## E5071B-12D

# S E R V I C E                      N O T E

## E5071B RF Network Analyzer, 300kHz to 8.5 GHz

**When E5071B has the old step attenuator (33321-60059) and Internal Test fails at Step Attenuator Test Group, replace the old attenuator (33321-60059) by improved version (33321-60068), add additional cable and update firmware to 5.02 or later**

**Figure 1 Make A7 assembly (for option 213 and for option314/414 with 1 attenuator)**

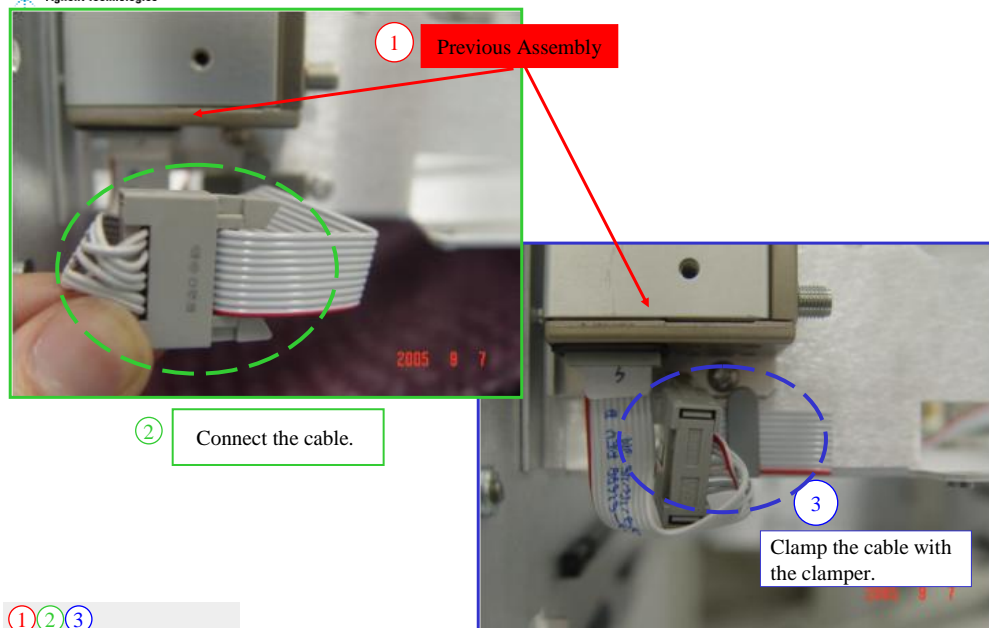
1. Disassemble the product. (Refer to E5070B/E5071B Service manual chapter 6 for details)
2. Make A7 step attenuator assembly by 33321-60068 (1ea), E5070-61698 (1ea), E5070-01213 (1ea), 0515-0372 (2ea) and E5070-61617 (1ea). E5070-61698 is the cable between 33321-60068 and E5070-61617. Scrap 33321-60059.
- 2-1. Scrap the flat cable that comes with the new attenuator (33321-60068).
- 2-2. Connect E5070-61698 to 33321-60068.
- 2-3. Connect E5070-61698 to E5070-61617.

**Figure 2 Install A7 attenuator assembly (1)**

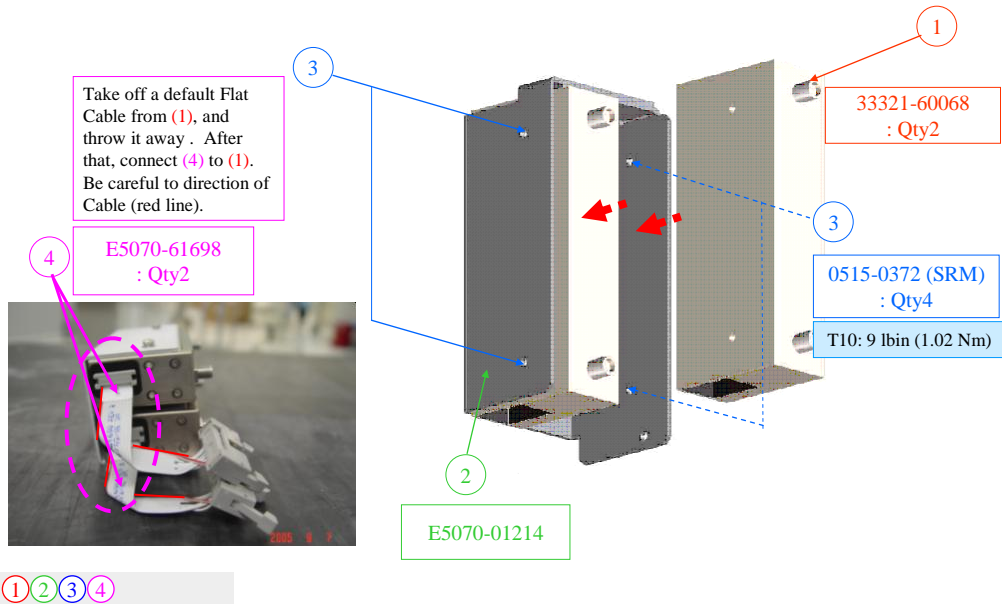
## 3. Install A7 assembly with 0515-0372 (2ea).

**Figure 3 Install A7 attenuator assembly (2)**

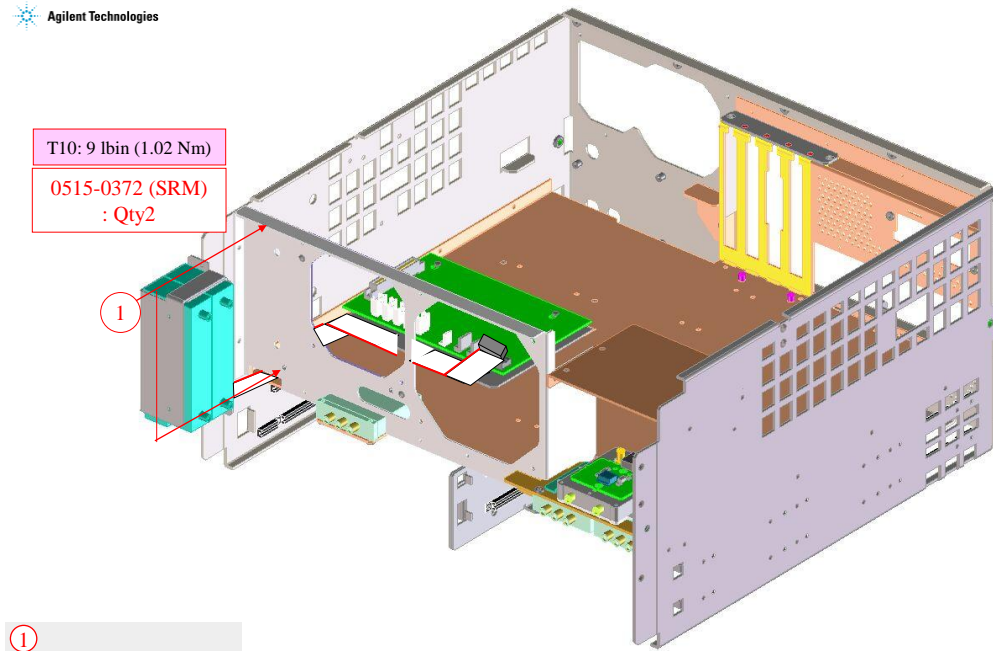
## 4. Connect the cable and clamp the cable with the clamber. Be careful to flat cable direction and its connectivity.

**Figure 4 Make A7 assembly (for option 314/414 with 2 attenuators)**

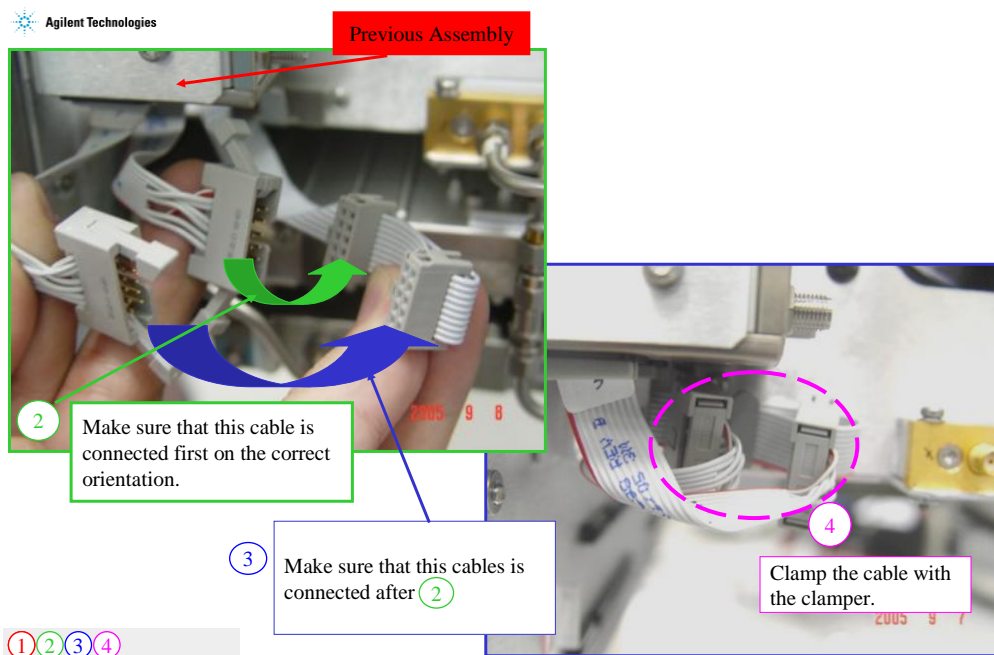
1. Disassemble the product. (Refer to E5070B/E5071B Service manual chapter 6 for details)
2. Make A7 step attenuator assembly by 33321-60068 (2ea), E5070-61698 (2ea), E5070-01214 (1ea), 0515-0372 (4ea) and E5070-61618 (1ea). 2ea of E5070-61698 are the cable between 33321-60068 and E5070-61618. Scrap 33321-60059.
- 2-1. Scrap the flat cable that comes with the new attenuator (33321-60068).
- 2-2. Connect E5070-61698 to 33321-60068. (This is done twice)
- 2-3. Connect E5070-61698 to E5070-61618.
